## **Annex 1: Accessibility**

The Enfield Town to Broxbourne Walking and Cycling Route is an active travel route that runs from the southern side of the M25 junction with the A10, along the New River and eventually on the local highway network towards Enfield Town. The off-carriageway section is an approximately 3m wide shared path running alongside the New River for approximately 2.9km.

The EQIA outlines the impact of the design on the nine protected characteristics as designed by the Equality Act 2010 as well as people who are disadvantaged due to socio-economic factors. This addendum supports the EQIA to provide additional information for some key considerations given to ensure an inclusive design.

**Figure 3 8% path alignment avoiding Saint Ignatius College**

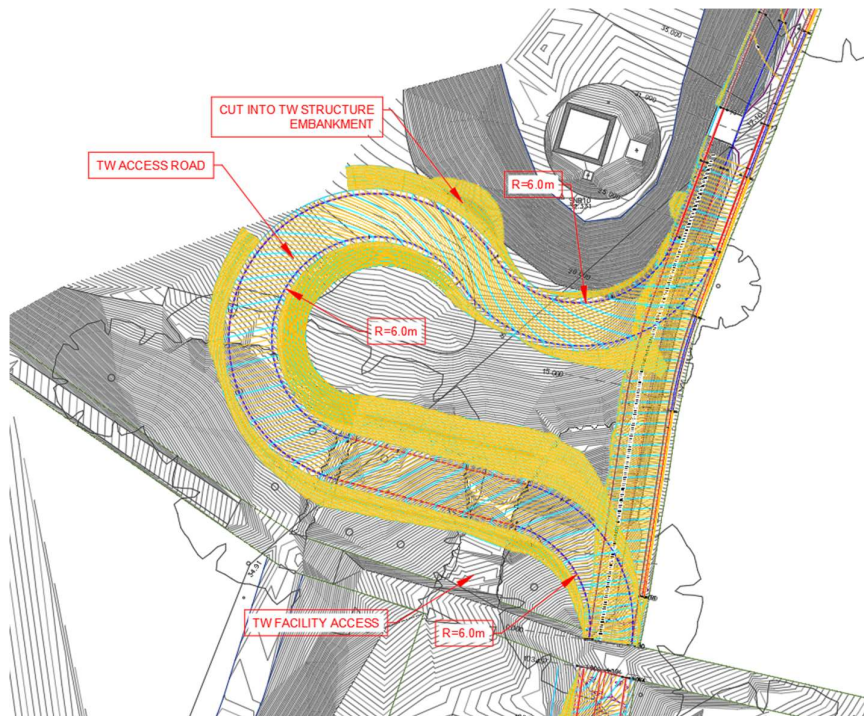
A longer path utilising additional Thames Water property was considered however the length of the path needed to achieve the level difference would need to be at least 60m towards the west, as outlined in Figure 3. This would clash with the existing Thames Water access road, would require extensive earthworks (cuts) in the vicinity of other Thames water structures and would require introducing 3 new 6m radius bends on the path.

**Figure 4 Sign-posted alternative route**

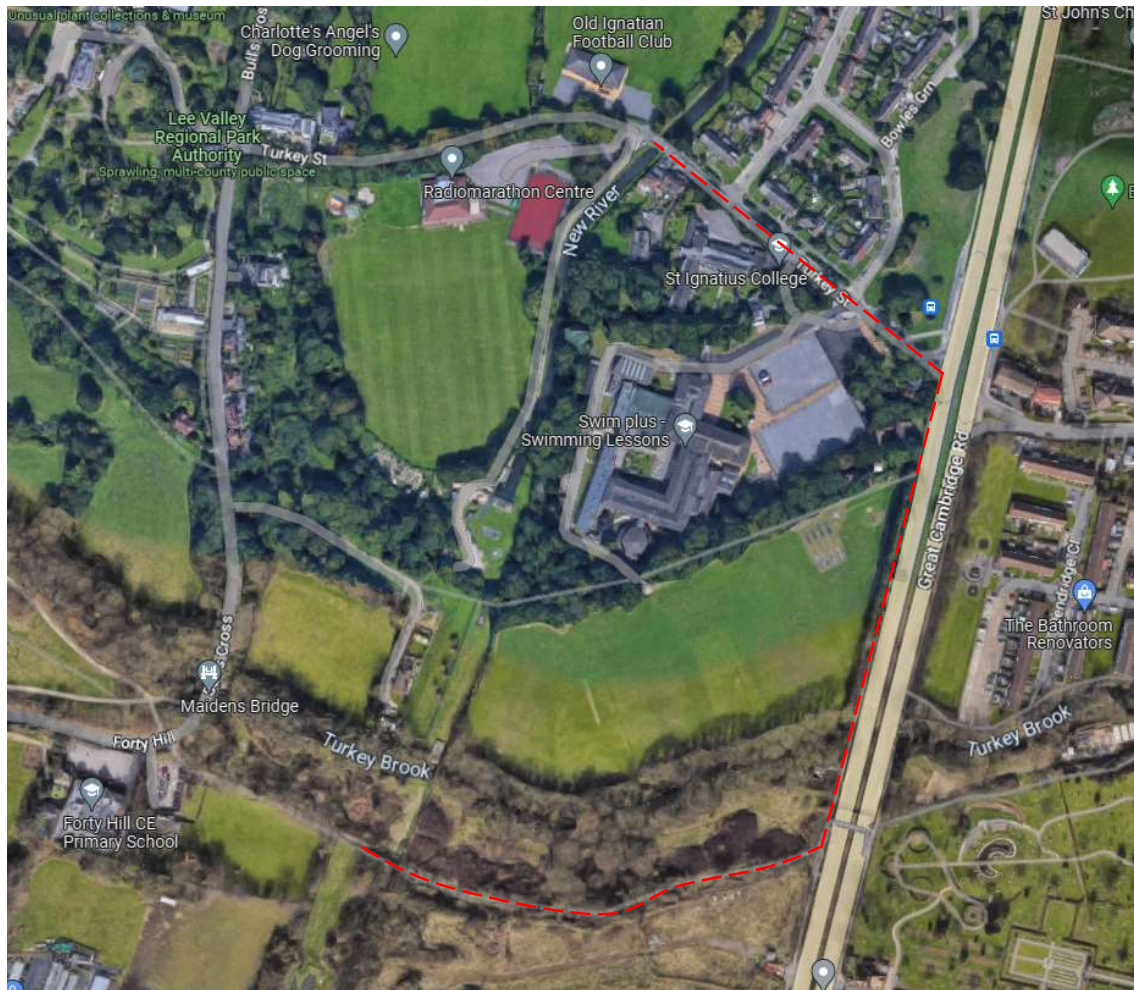
The alternative route that would be sign posted is in Figure 4. It is approximately 850m, whereas the direct route along the New River is approximately 450m. Therefore, the detour adds approximately 400m of additional travel. This route avoids the steep gradient and utilises the concrete surfaced greenway, the footpath along the A10 and the footpath on the northern side of Turkey Street, re-joining the New River Path at Turkey Street. There is a short 50m length of Turkey Street, from Capel Road to the Turkey Street Bridge, which does not have a footpath. Vehicle usage along this short stretch is expected to be minimal because it only provides access to four driveways.
